ADDENDUM NO. 2

DATE OF ISSUANCE: March 21, 2023

PROJECT: 2023 Henryville Flooring Replacement
Phase 2 & Cafeteria Expansion
213 N. Ferguson. St.
Henryville, IN 47126

ARCHITECT'S PROJECT NO.: 21-47.007

1
A501

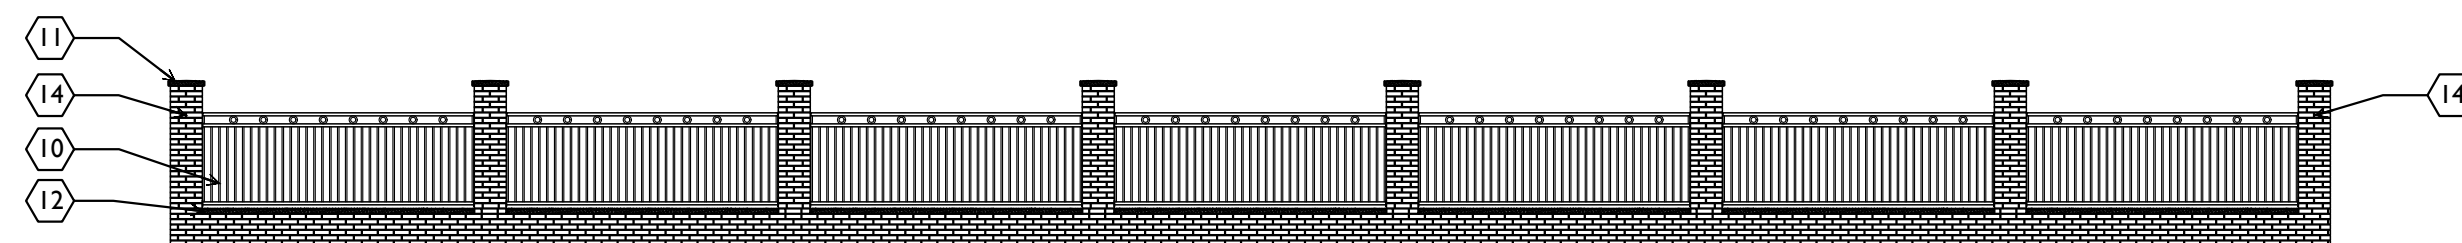
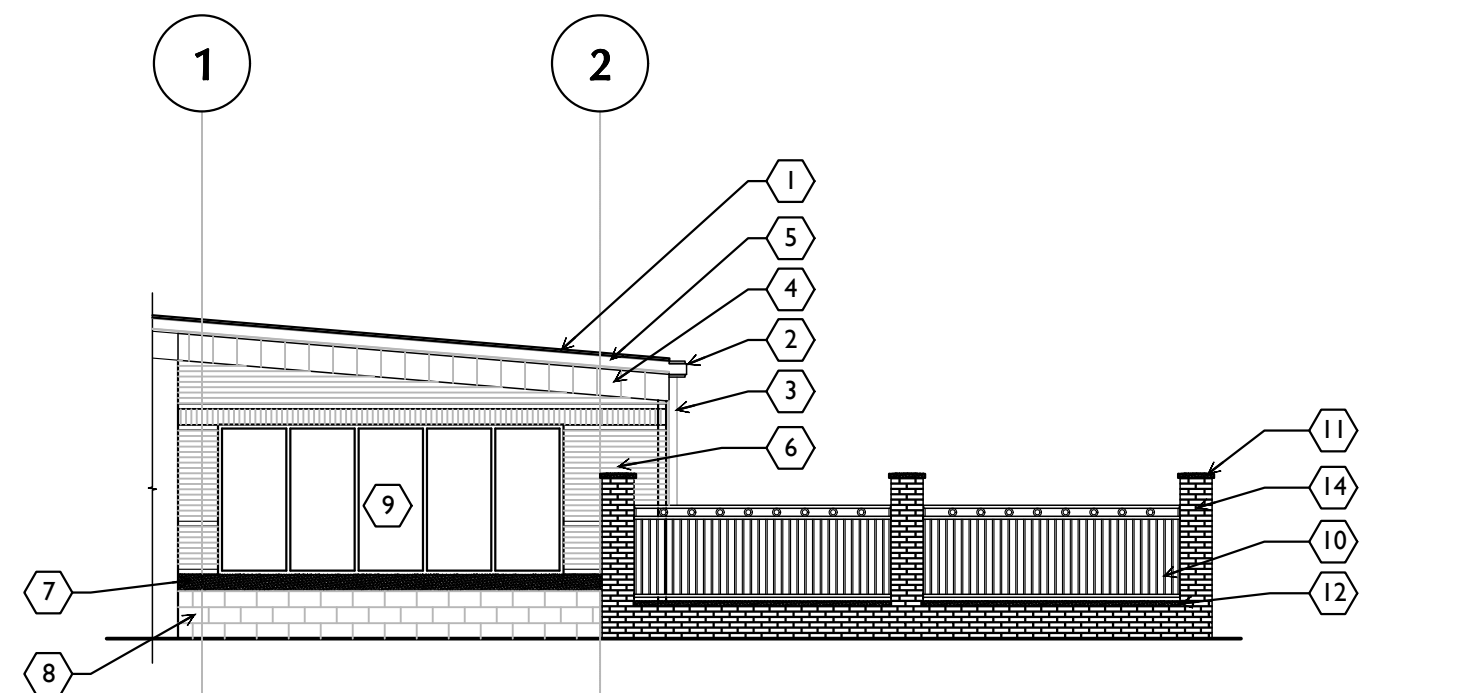
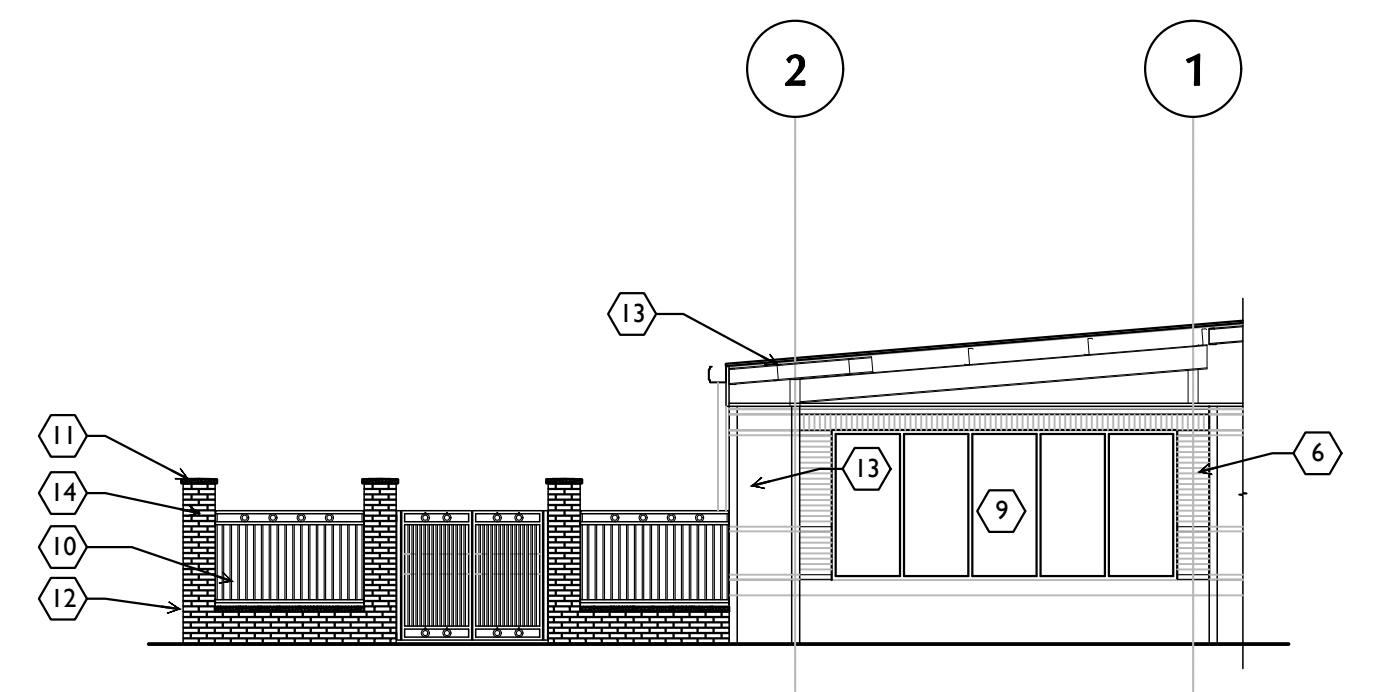
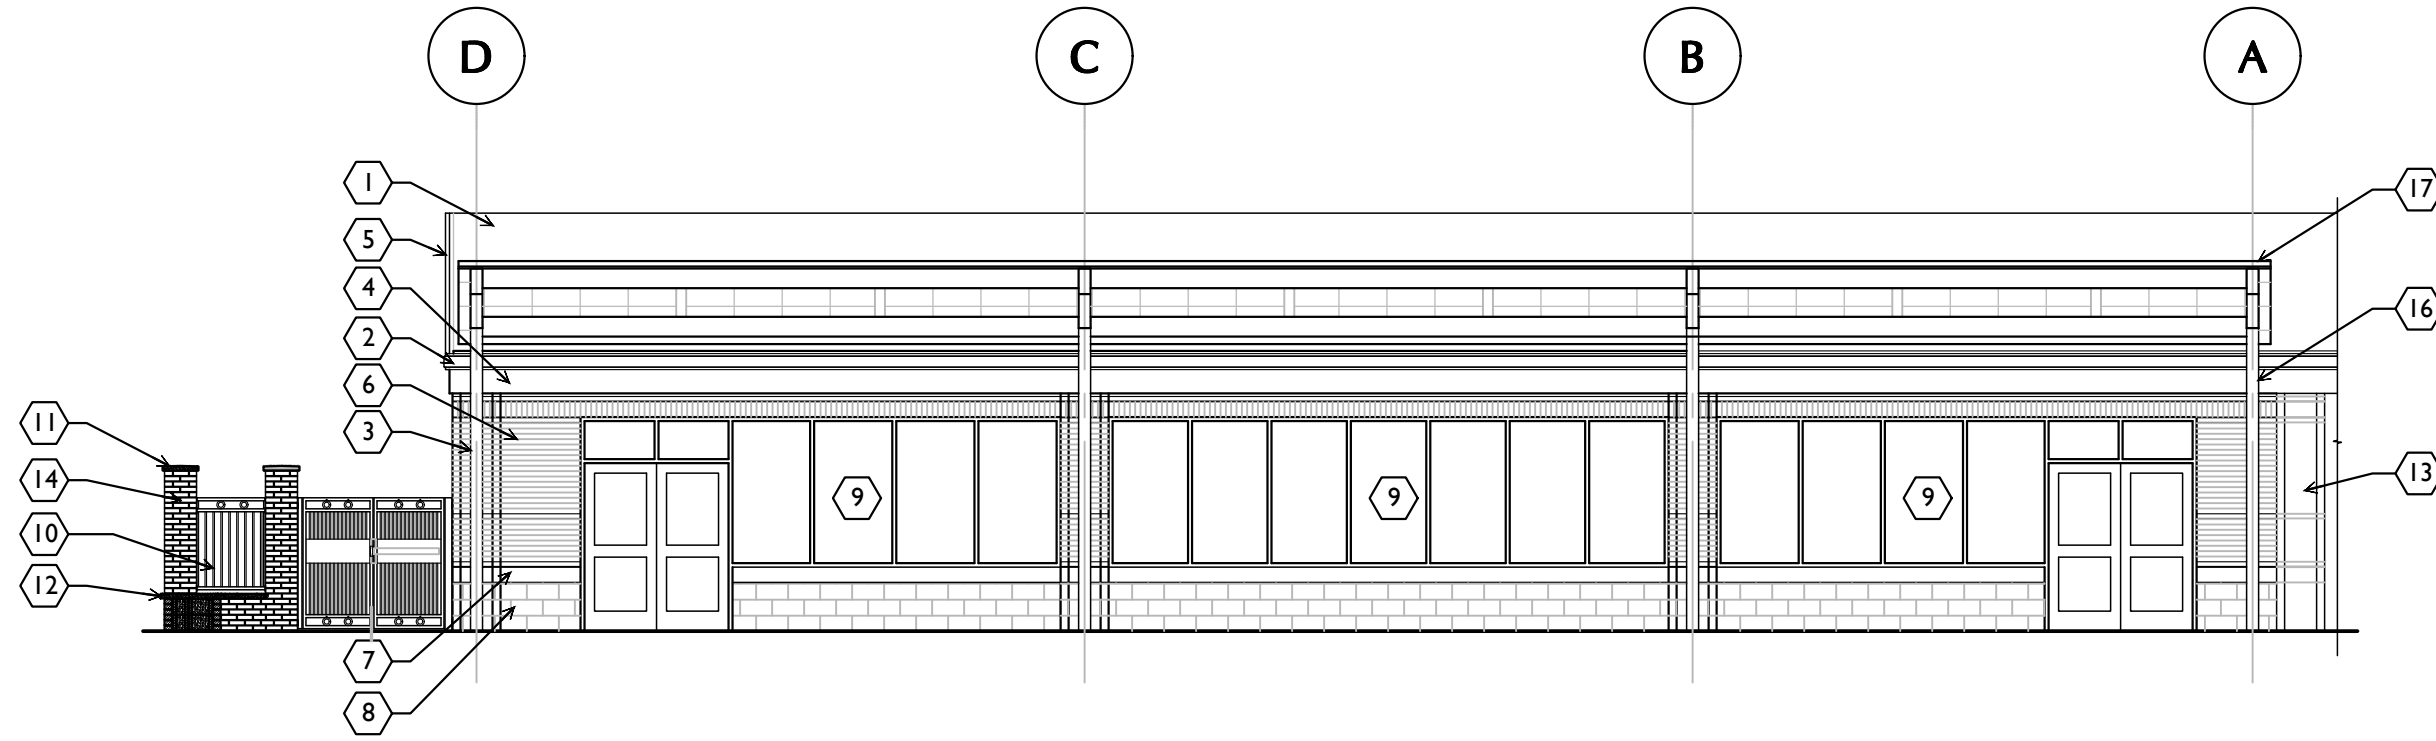
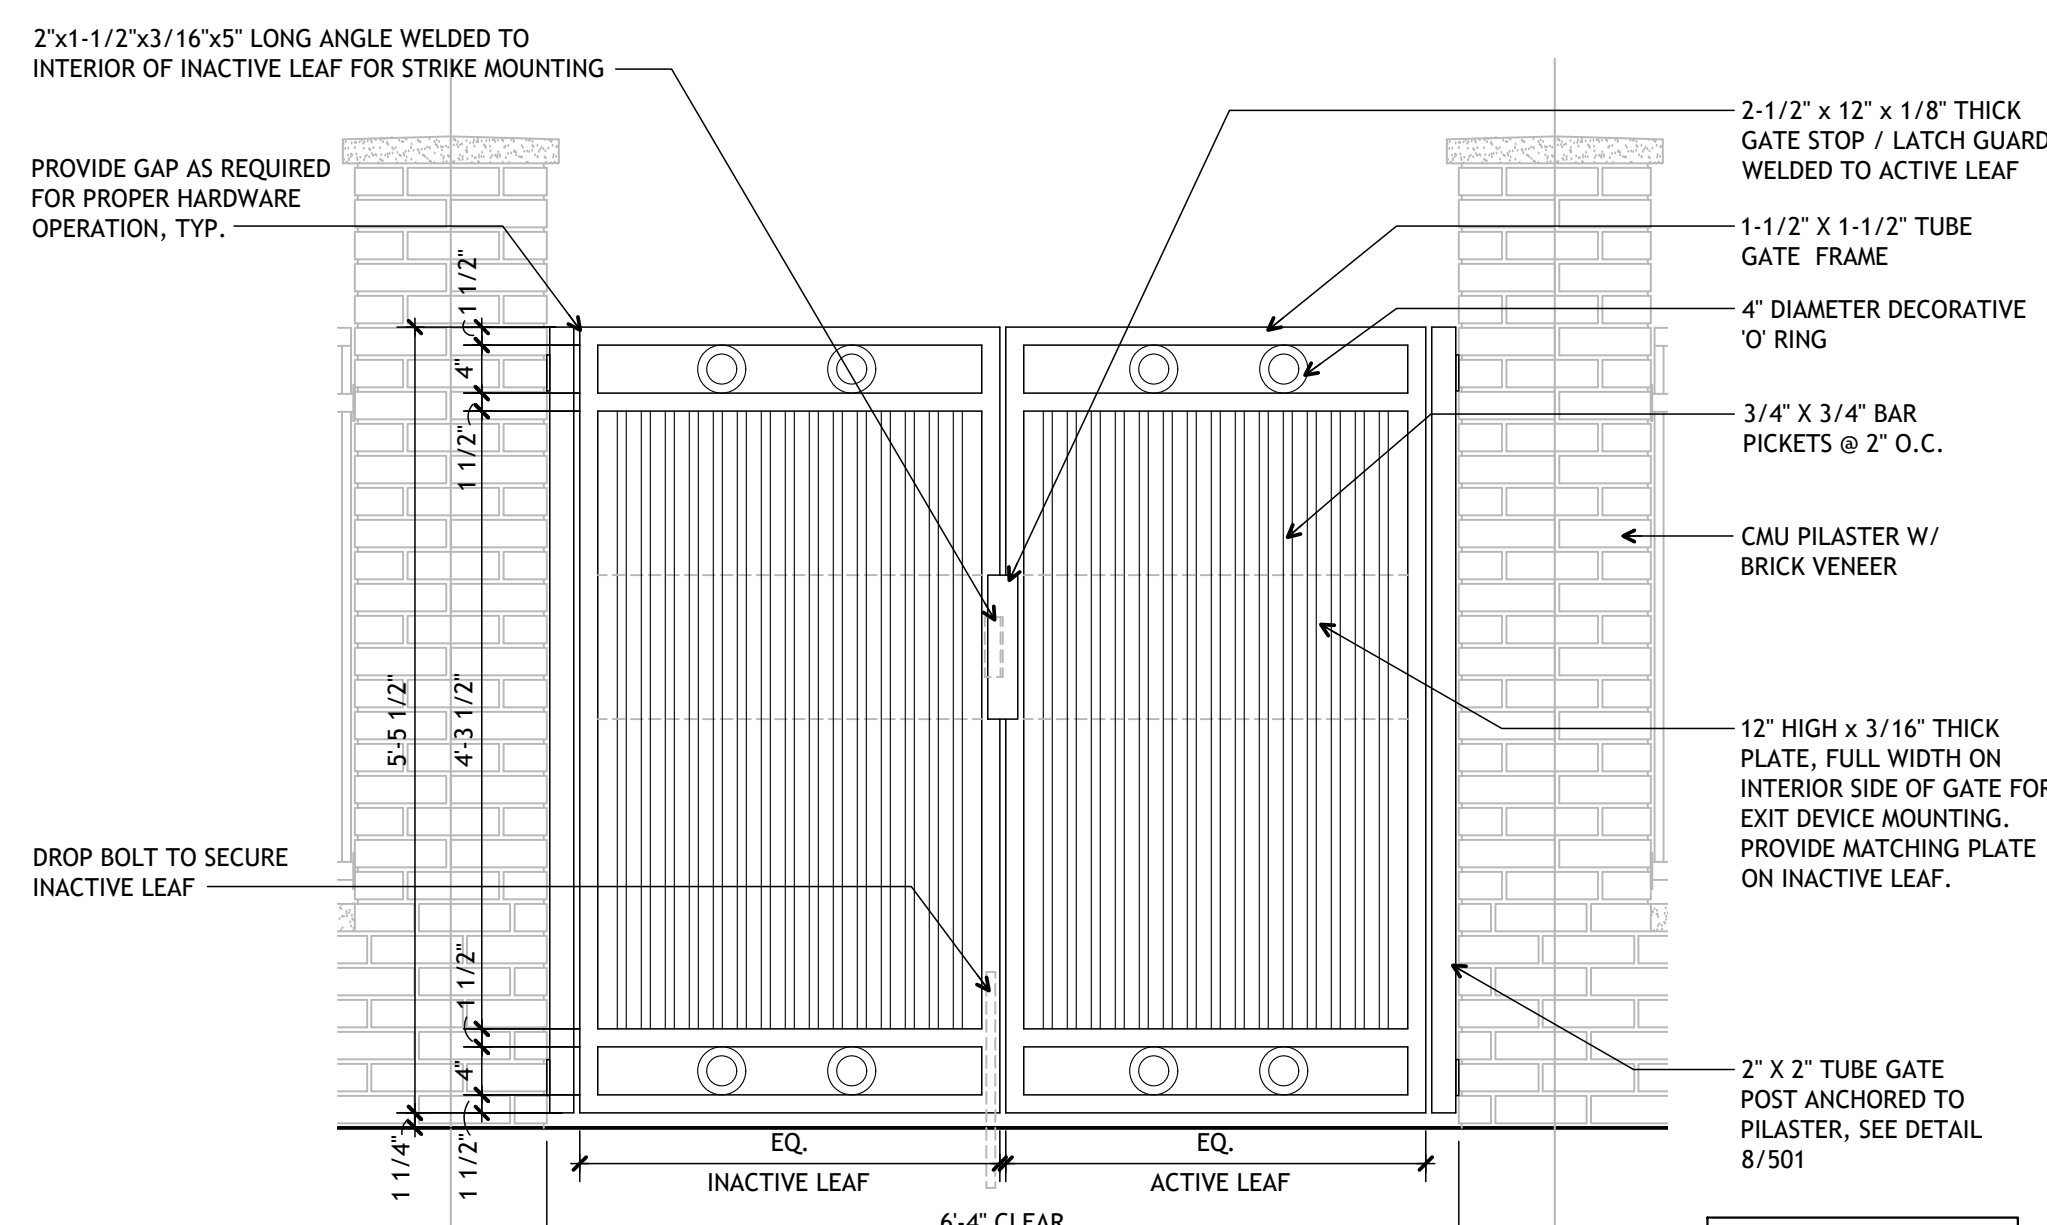
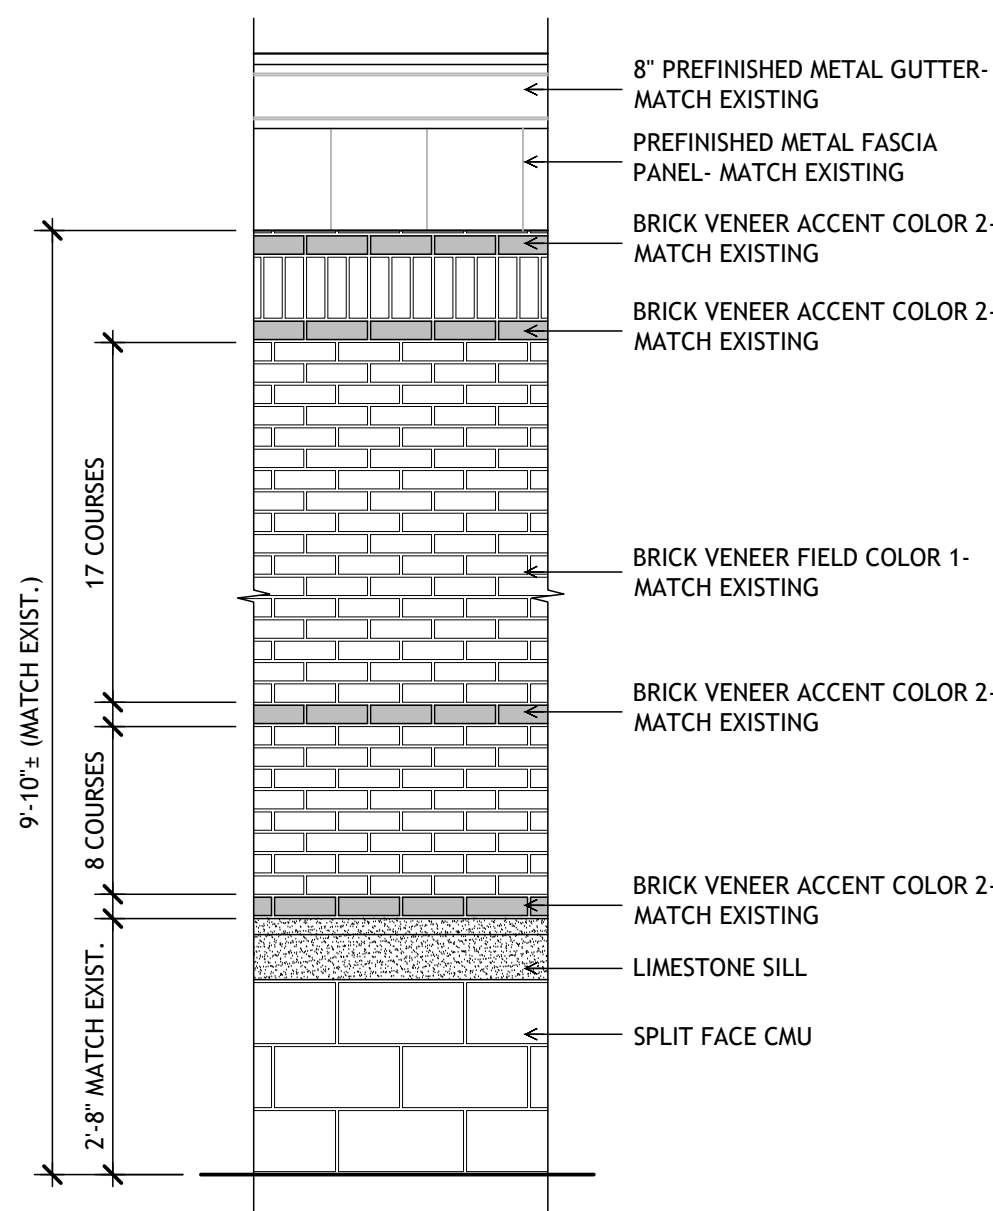
ADD-1 Item No. D-8 - Exterior Elevations

Refer to Sheet(s): A501

Replace with attached revised Drawing in its entirety; revisions have been clouded for reference.
